The objective of this Global Technical Regulation (“gtr”) is to establish a harmonized regulation which ensures off-cycle emissions from heavy-duty engines and vehicles are appropriately controlled over a broad range of engine and ambient operating conditions encountered during normal in-use vehicle operation. The gtr is designed to be applicable to engines certified or type approved under the test procedures of the World-Harmonized Heavy-duty Certification (WHDC) gtr.

This gtr was developed by the GRPE informal working group on Off-cycle Emissions (the OCE Informal group). A full report of the work of the OCE Informal group, its deliberations and conclusions is provided in the group's Technical Report, TRANS/WP.29/GRPE/xxxxx.

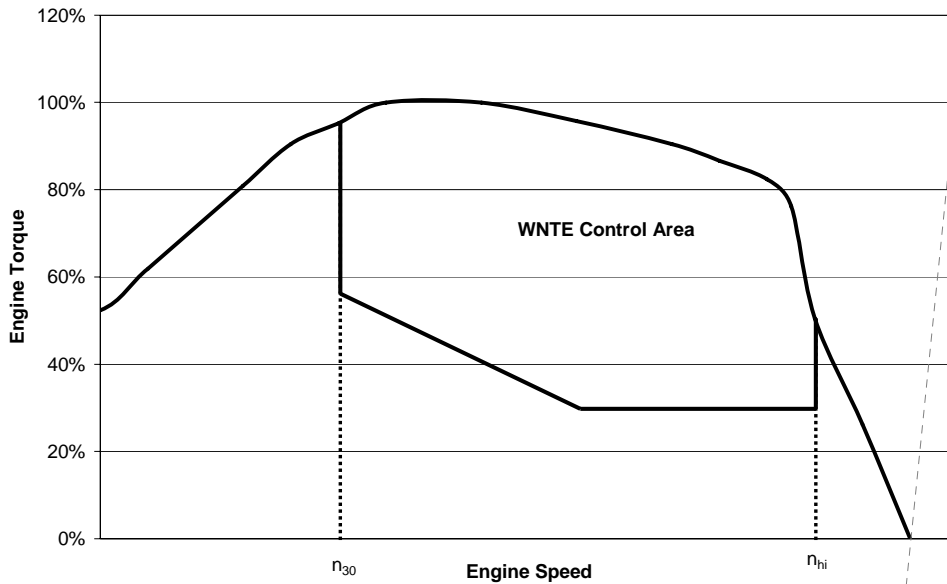
**Editorial Comment: Will update diagrams to correspond with final control area established in gtr and will add example figures without PM carve out.**
